Subject: National Highways response: Y/10/22/PL, Land to the south of Ford Lane and east of North End Road, Yapton

Application No: Y/10/22/PL

Site: Land to the south of Ford Lane and east of North End Road, Yapton, BN18 0DS

National Highways Planning Response (NHPR 21-09)
Formal Recommendation to an Application for Planning Permission

TITLE: PROPOSED EXTENSION TO A27 YAPTON LANE RIGHT TURN		SCALE @ A3: 1:1000	CHECKED: MC	APPROVED: TW
PROJECT: LAND EAST OF TYE LANE WALBERTON		FILE REF: ITB11324	DRAWN: AB	DATE: 23.05.17
CLIENT: WATES DEVELOPMENTS		DRAWING No: ITB11324-GA-014		
		PROJECT No: ITB11324		REV: C

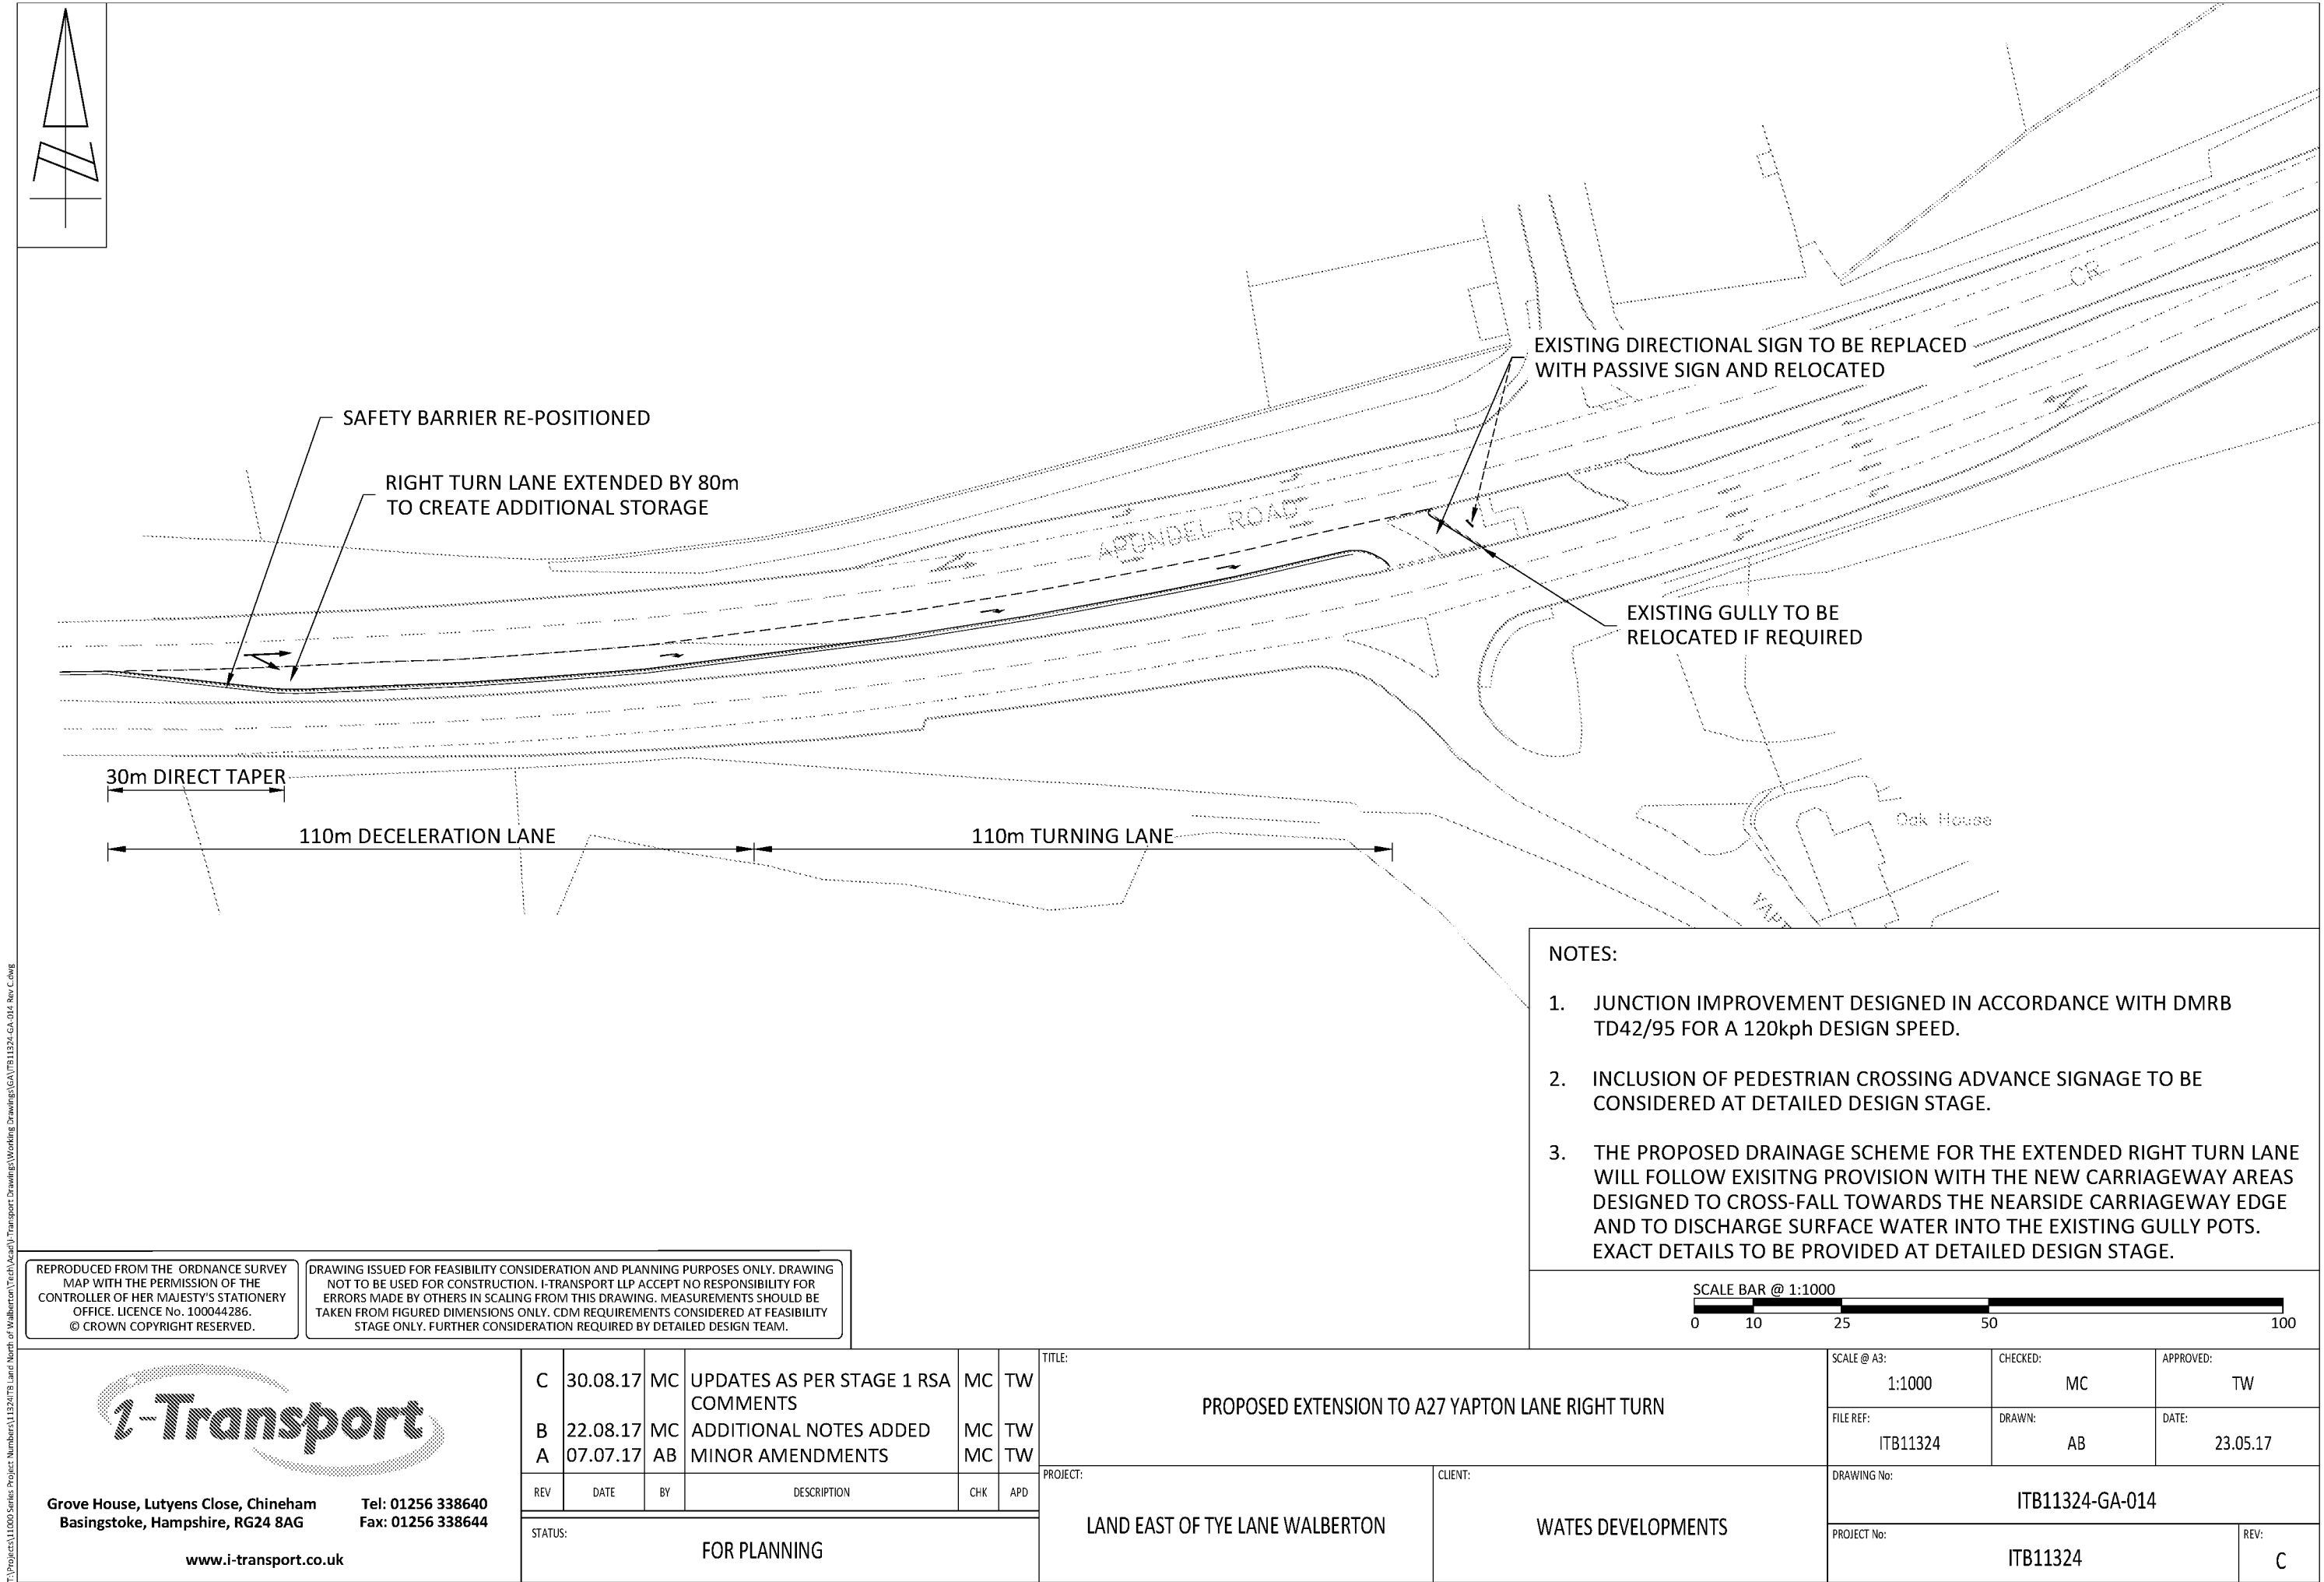
National Highways has recommended conditions for planning proposals in Yapton parish over recent years requiring works to extend the right turn lane at the A27 / Yapton Lane junction. This is necessary on safety grounds to provide sufficient length for vehicles to decelerate before waiting/queueing to turn right into Yapton Lane. The improvement has not yet been implemented and housing occupancy has increased adding pressure on this junction. National Highways can no longer tolerate any further intensification of use of this junction until the improvement is in place because of the threat to the safety to road users.

As stated in our response of 20 December 2021 to the Yapton Neighbourhood Development Plan Regulation 16 Consultation, we consider that any additional housing development beyond that already committed will require the A27 / Yapton Lane right turn lane mitigation to be in place prior to occupancy. Accordingly, we require that no dwellings are occupied until the A27 / Yapton Lane right turn lane mitigation is completed and open to use.

Condition: No dwellings in the development hereby permitted shall be occupied until the completion and opening to the travelling public of the improvements to the A27 / Yapton Lane junction shown on drawing number ITB11324-GA-014 Revision C "*Proposed extension to A27 Yapton Lane right turn*" dated 30/8/2017 (or such other scheme of works substantially to the same effect, as may be approved in writing by the local planning authority (who shall consult with National Highways)).
